Building Consent No:33055
Section 51, Building Act 2004

Building Name: NEW DWLG/GARAGE

Intended Use: NEW DWELLING/GARAGE - 83M2

I acknowledge receiving your Building Consent Application dated 18.1.06, to construct a dwelling/garage but wish to advise that the plans and specifications submitted do not fully comply with the Building Code and/or legislation. Further processing of this Consent will be suspended until amendments or the required additional information is received. The permitted period of suspension will be up to 20 working days within which time it is considered all information should have been submitted.

*NEW SET OF PLANS SUPPLIED
13 SHEETS*

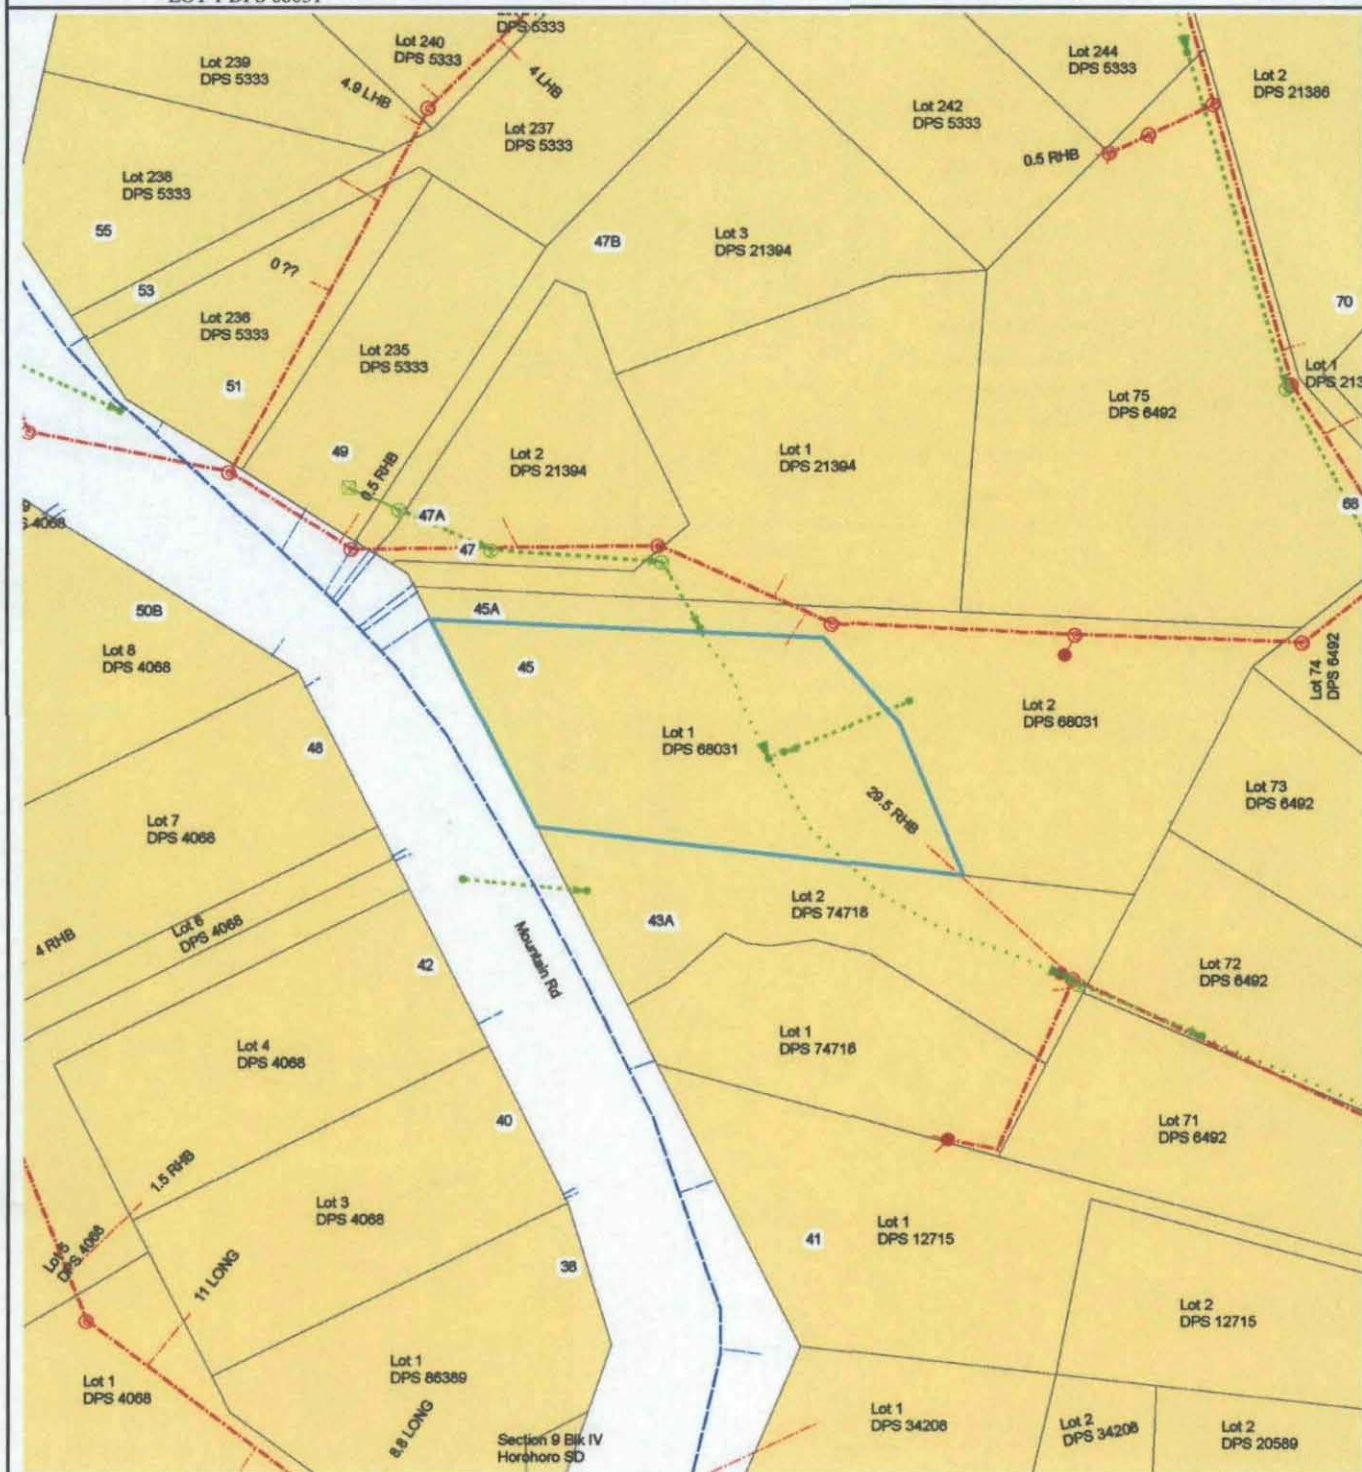
- ✓ • Plinth on top of block bond beam must be of concrete as opposed to timber as shown (detail on 4/11); amend plans. *ALTERED*
- ✓ • Soakhole positioned adjacent to existing dwelling may undermine existing foundation (please detail an alternative position). *- ALTERED & COMPLIES WITH PIM*
- ✓ • Fixing of boundary deck joist to joists adjacent to balusters to be detailed to comply with ZBC B1 figure 4. *ON SH 13*
- ✓ • Junction between differing claddings to be detailed. *SH 11*
- ✓ • Please demonstrate how you mean to comply with NZBC clause E2 9.1.8.5 and 9.1.4. *ON SH 7*
- ✓ • The fall of the section to the retaining wall is not a robust detail and consideration should be given to diverting this catchment area as detailed in NZS 3604:1999, figure 7.11. ✓

Site Plan Scale 1:250

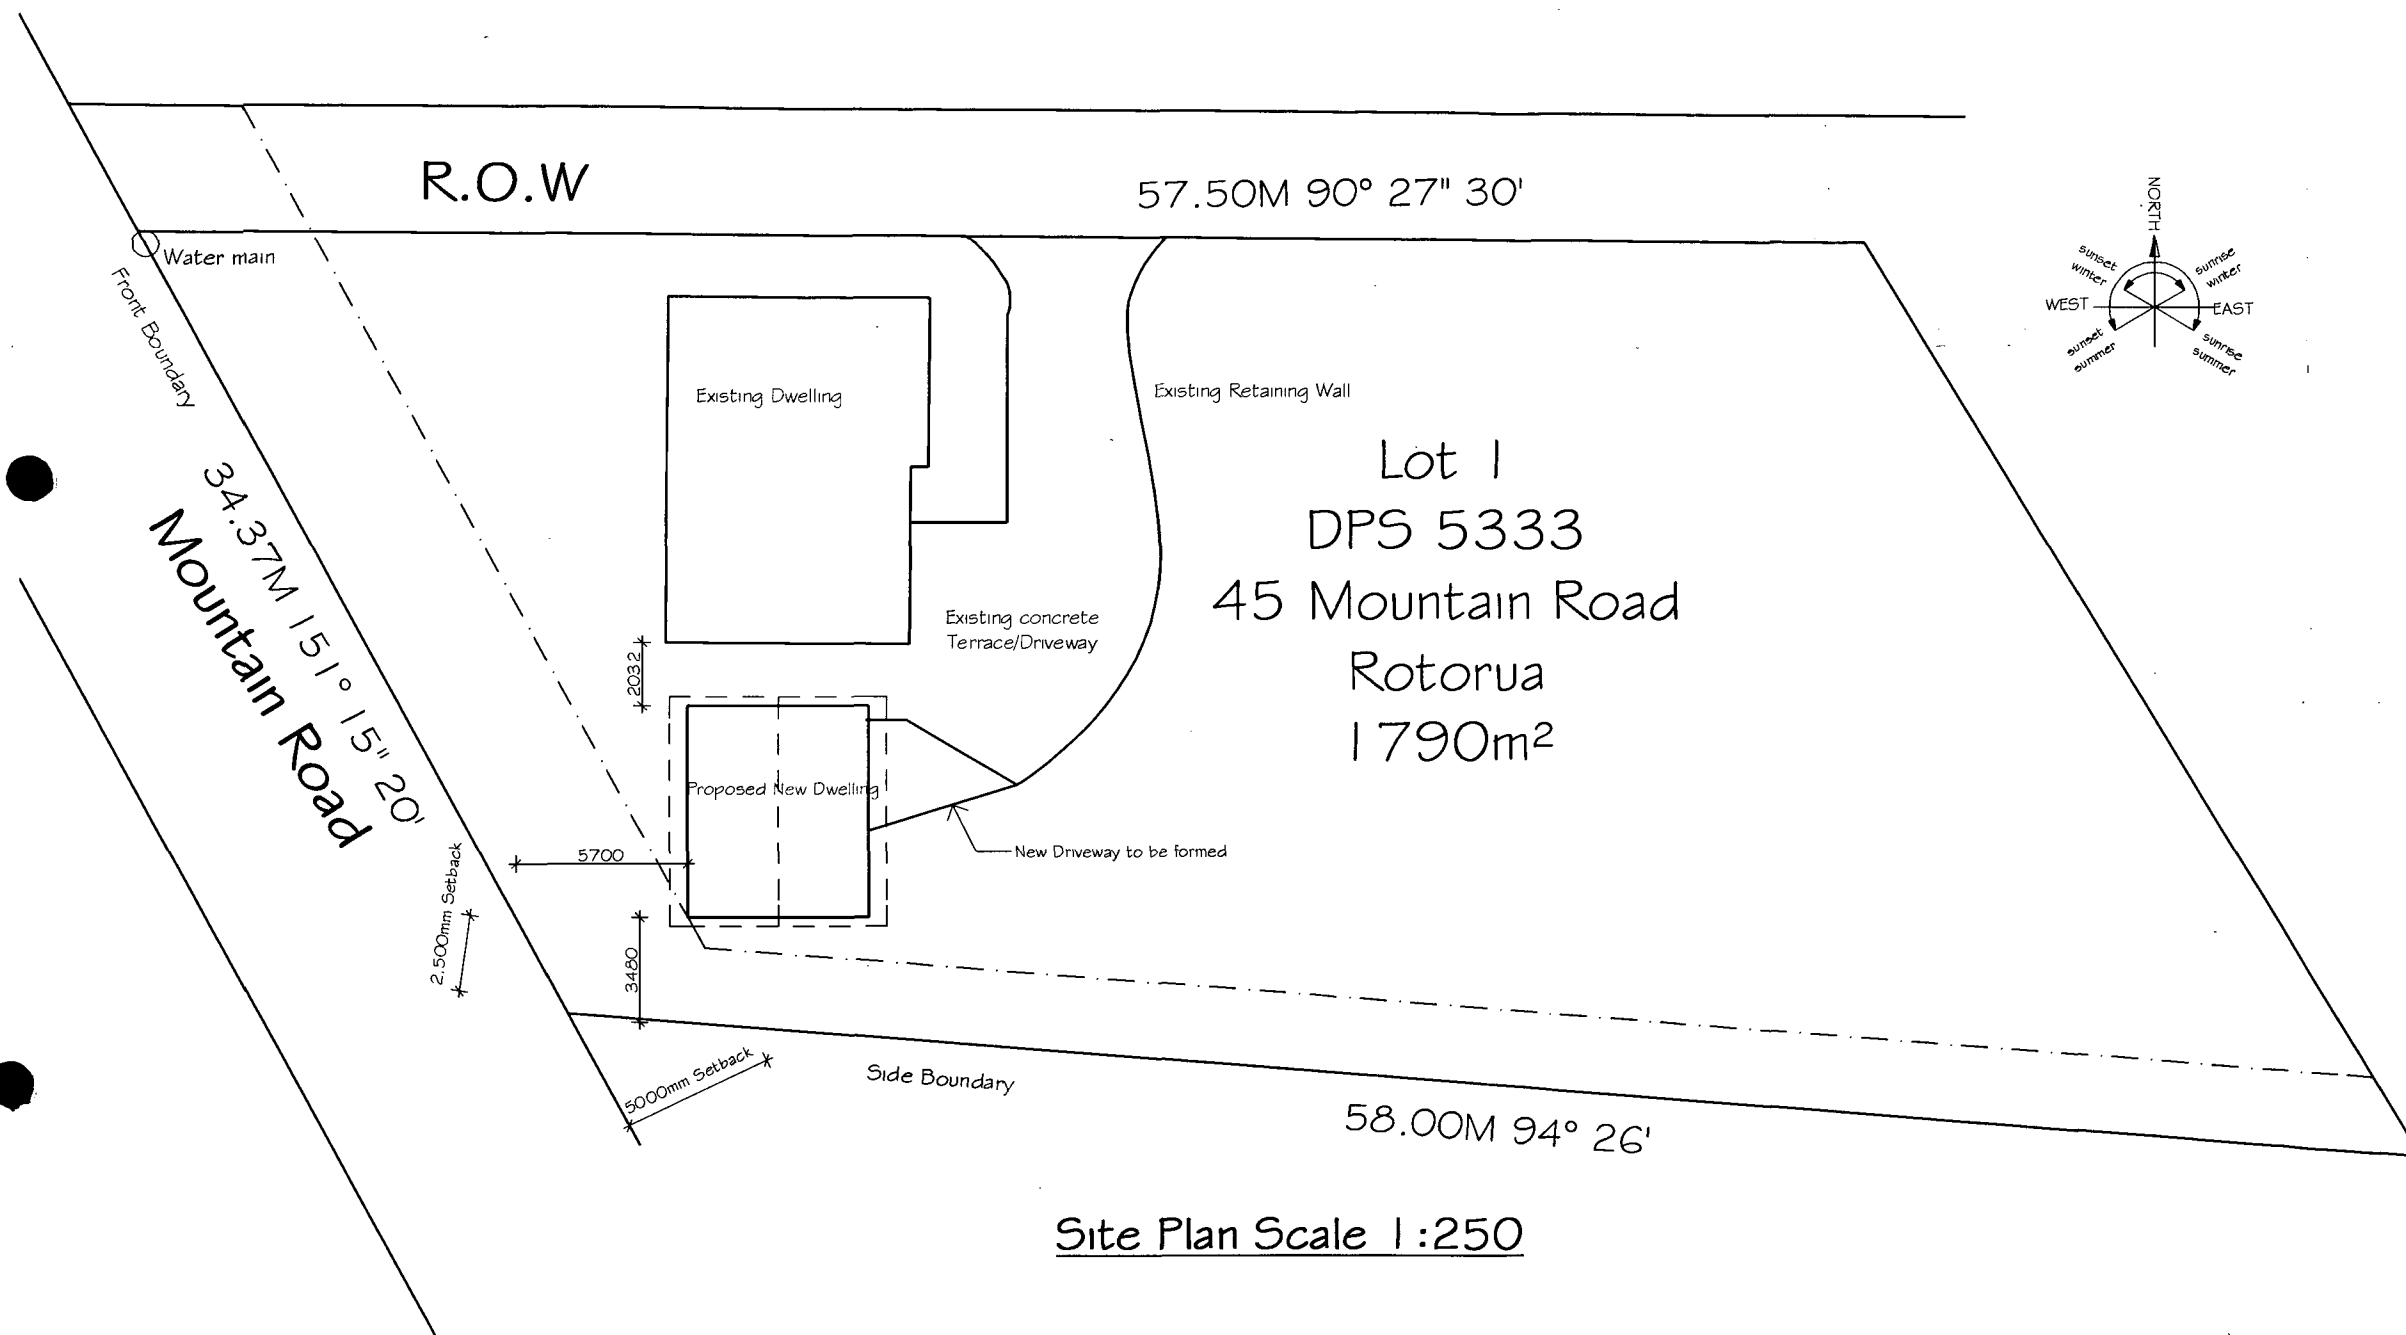
314 f) Due to the steepness of this site it would be preferable to direct the stormwater from the roof of the proposed dwelling directly to the open stormwater drain crossing the property rather than to a soak hole near the top of the hill as shown on your plans.
